UNITED STATES PATENT AND TRADEMARK OFFICE

APPLICATION NO.	FILING DATE	FIRST NAMED INVENTOR	ATTORNEY DOCKET NO.	CONFIRMATION NO.
10/813,928	03/31/2004	Admir James Mesalic	MES1.002	5800
39863	7590	02/15/2007	EXAMINER	
SONNABENDLAW			EDELL, JOSEPH F	
600 PROSPECT AVE			ART UNIT	
BROOKLYN, NY 11215			PAPER NUMBER	
			3636	
SHORTENED STATUTORY PERIOD OF RESPONSE	MAIL DATE	DELIVERY MODE		
3 MONTHS	02/15/2007	PAPER

Office Action Summary

DETAILED ACTION

Diagram A - Annotated Figure 6 of Sugawara in view of Kerrigan

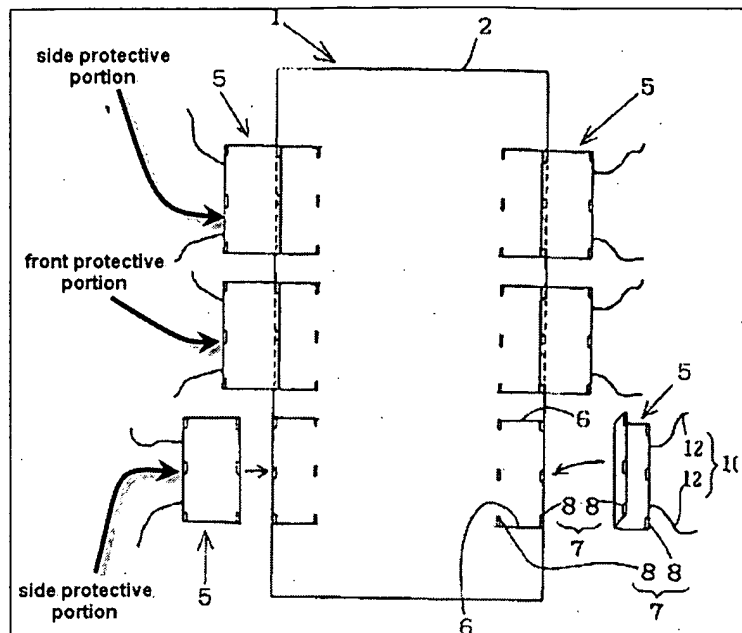
Sugawara discloses a protective covering that is basically the same as that recited in claims 8, 9, 11, 12, 35, 39, and 40 except that the covering lacks a front

protective portion disposed between two side protective portions, as recited in the claims. See Figures 1 and 6 of Sugawara for the teaching that the protective covering has a main protective portion/main placemat area 3 with top and bottom surfaces of vinyl (column 3, lines 1-5), a front protective portion/front flap (attached piece 5) attached to the main protective portion and *capable* of operatively attaching to a front arm portion of a child's chair and of extending from a table top to the child's chair, and a side protective portion (piece adjacent the front protective portion) attached to and extending from the front protective portion wherein front protective portion has a proximal end adjacent to the main protective portion and a distal end opposite the proximal end, proximal coupling elements 8 on the proximal end of the front protective portion and positioned at a juncture between the main protective portion and the front protective portion's proximal end, distal coupling elements 8 at the distal end of the front protective portion and positioned an edge of the front protective portion's distal end, the proximal and distal coupling elements being *capable* of release coupling of the protective covering to a front arm of a chair by connecting the proximal coupling elements to the distal coupling elements, the side protective portions has left and right sides, at least one of the side protective portions being *capable* of operatively attaching around one side arm portion of the child's chair by operatively connecting the left side of the at least one side protective portion to the right side of the same side protective portion, the coupling elements are ribbon ties/hook-and-loop fasteners, and the side arm portions are orthogonal to the front protective portion. See Figure 10 of Sugawara for the teaching that unused pieces 5 are folded over to attach fasteners 8 thereby

creating a pocket of the main protective portion, and, therefore, teaching the limitation recited in claim 11. Kerrigan shows a protective covering similar to Sugawara wherein one side of the main protective portion has a front protective portion 3 (see Fig. 11) and two side protective portions (elements both side of element 3) such that the front protective portion is disposed between the two side protective portions.

Therefore, it would have been obvious to one having ordinary skill in the art at the time the invention was made to modify the protective covering of Sugawara such that the covering has an additional protective portion wherein the additional protective portion forms a second side protective portion with coupling elements on its left and right sides such that the front protective portion is attached to and extends between the two side protective portions (see Diagram A below), such as the protective portion disclosed by Kerrigan. One would have been motivated to make such a modification in view of the suggestion in Kerrigan that the configuration allows for greater storage of dining utensils, napkins, and/or plates, and in view of the knowledge generally available to one of ordinary skill in the art that a table covering with three protective portions will accommodate three users on a single side.
